DANE COUNTY DEPARTMENT of PUBLIC WORKS, HIGHWAY and TRANSPORTATION

ADDENDUM NO. 2

RFB NO. 108019 - NEW AIR CONDITIONERS & GENERATOR

DANE COUNTY PUBLIC WORKS

1. Drawing 1 - Construction Drawings and Floor Plans (Revised 02/19/08)
2. Drawing 3 - Optional Run 5th Floor Plan (Revised 02/19/08)

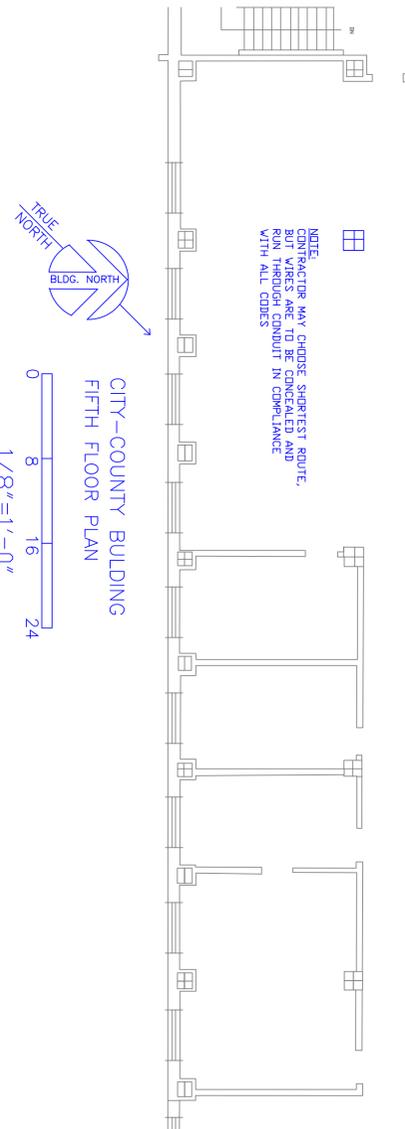
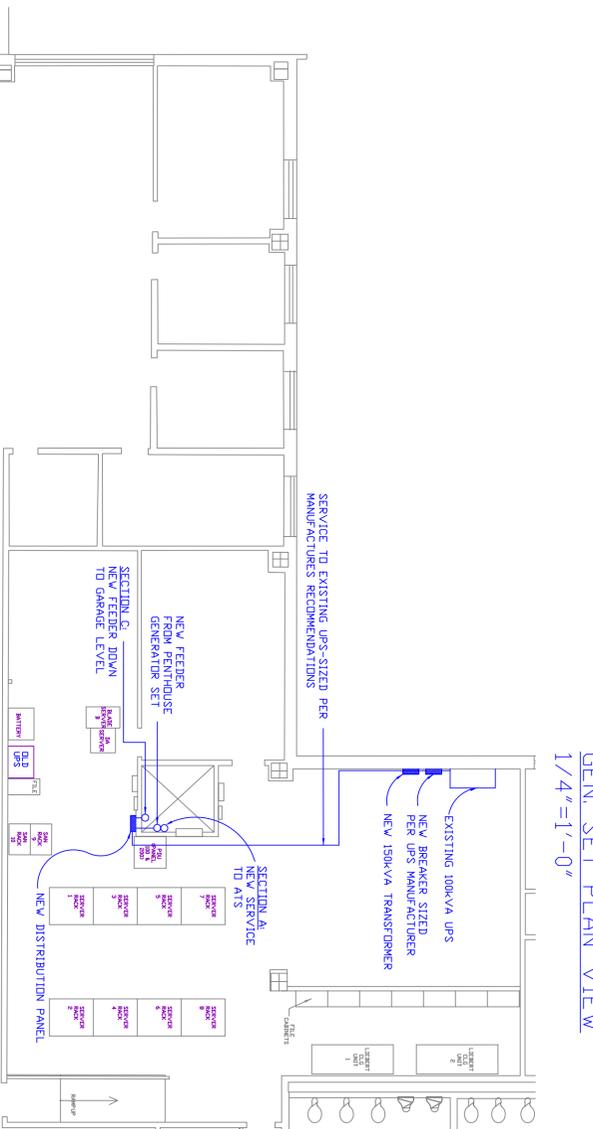
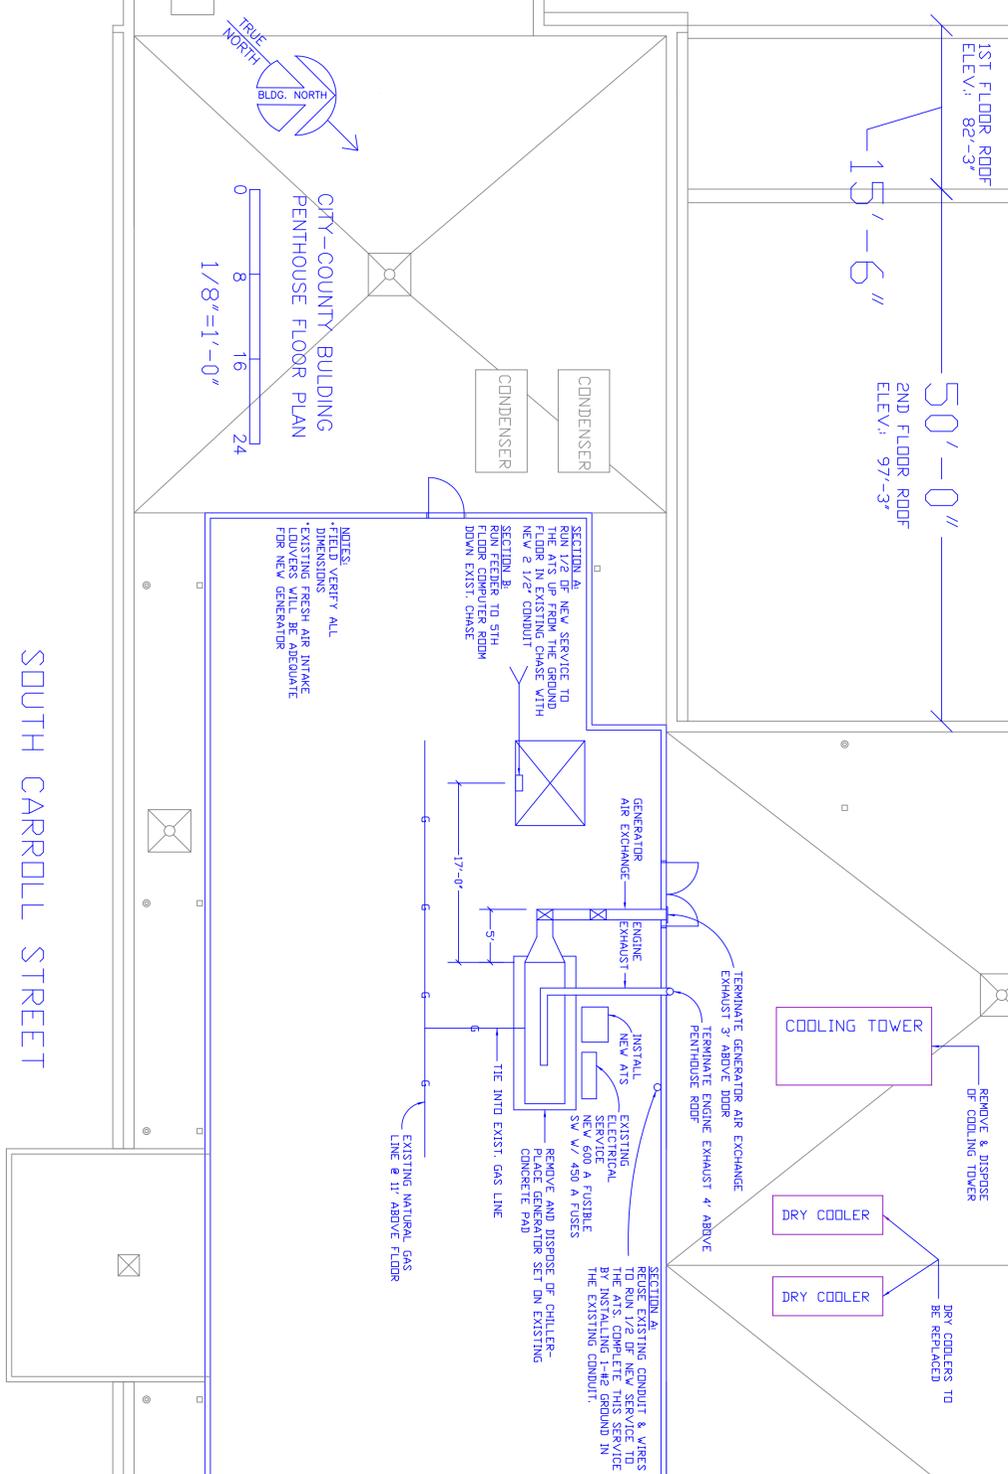
1. The 100 KVA UPS in the County's 5th Floor computer room was shown in the wrong location on the Drawings. The previous Drawing showed the location of an older UPS. The location of the UPS that is included in this Work is shown on the revised Drawing 1 and Drawing 3, which are attached.

2. A contractor asked about the need for a new breaker for the UPS in the 5th floor computer room, as shown on the Construction Drawings and Diagram 1. The existing UPS's breaker is located on the ground floor, and that location makes it extremely inconvenient during system testing. Therefore, the new breaker is needed as shown. It can be located in a new panel on the wall adjacent to the existing 100 KVA UPS.

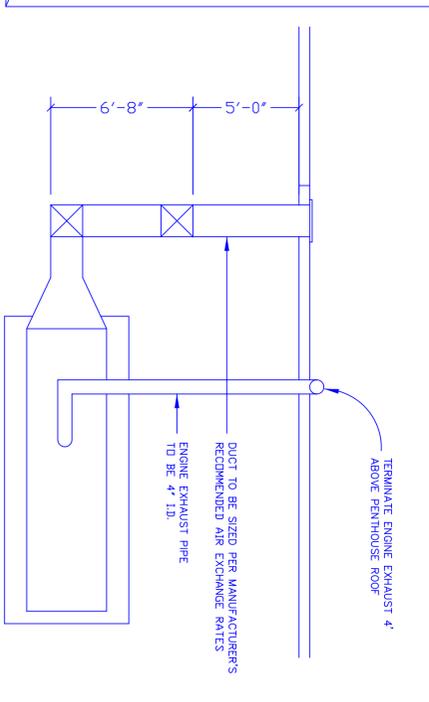
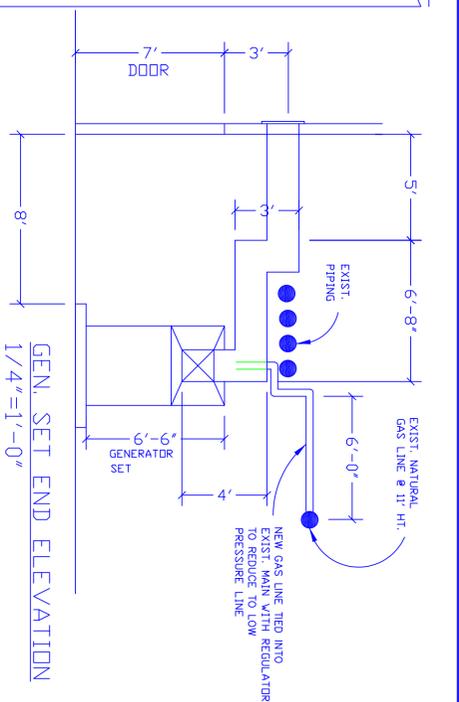
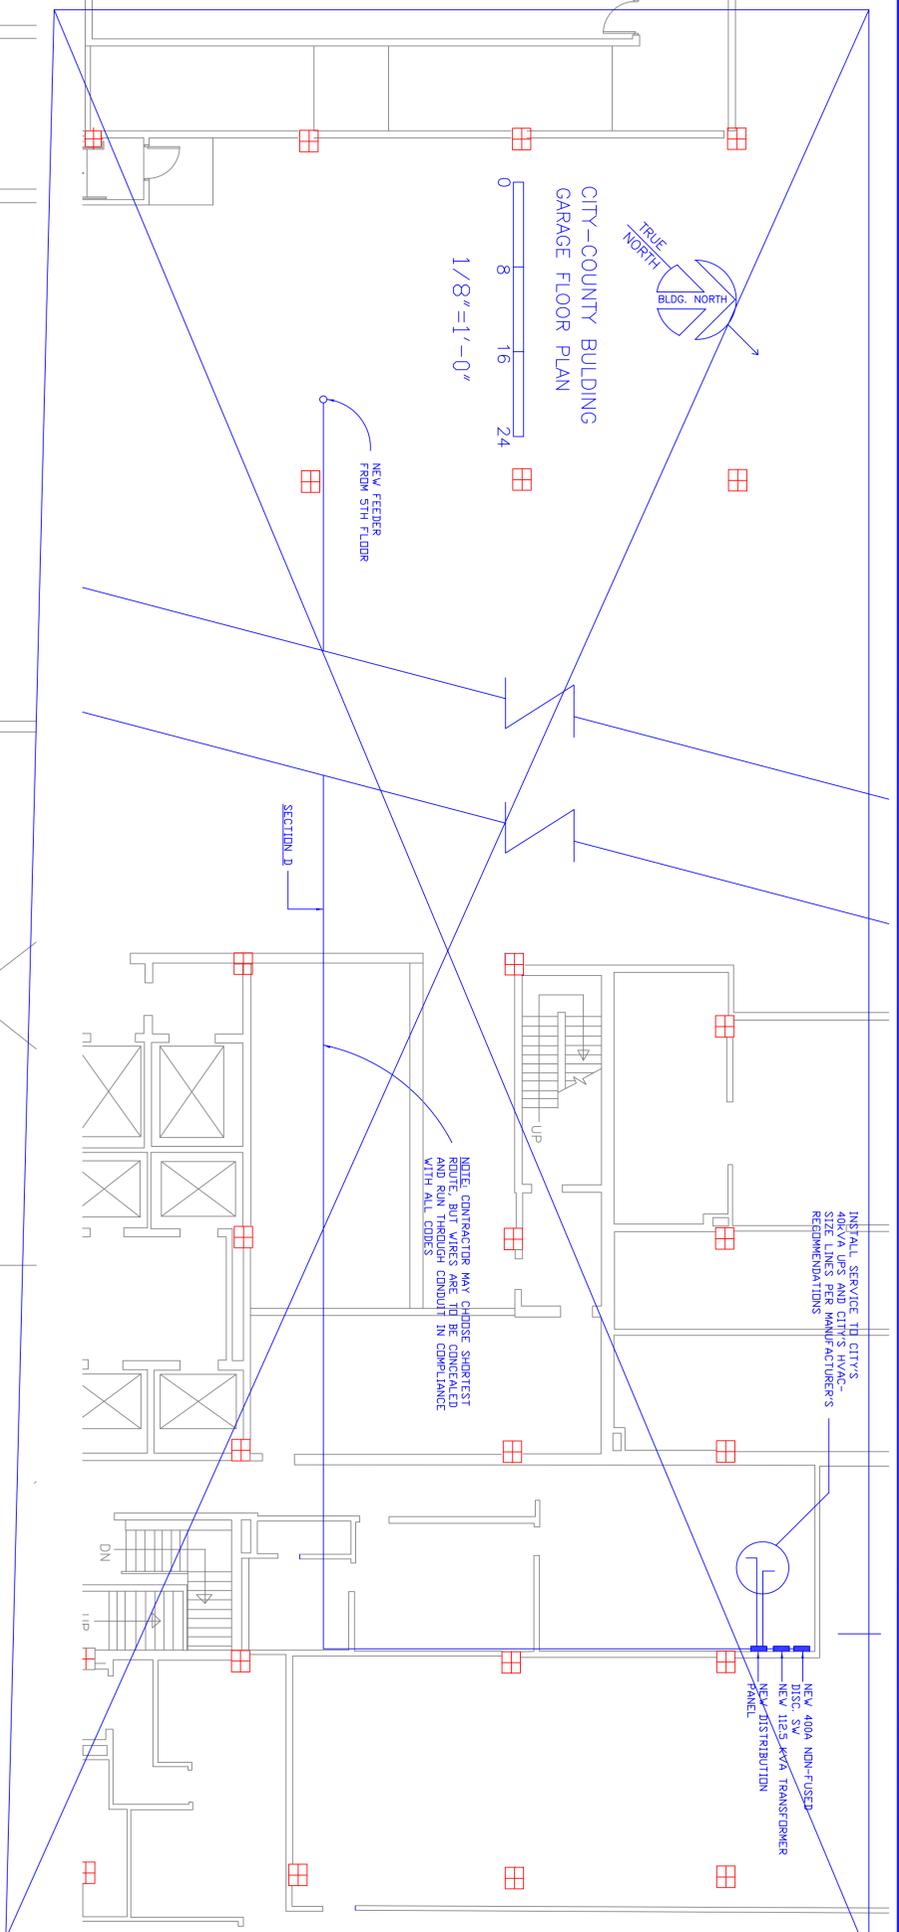
4. Optional Run Only – Do not install the 5th Floor transformer in the computer room, as shown on previous Drawings. Locate the 5th Floor transformer with the distribution

panel, in the room behind the stairwell. The feeder from this transformer to the 5th Floor breaker should be resized per manufacturers recommendations. This is shown on the attached revised Drawing 3.
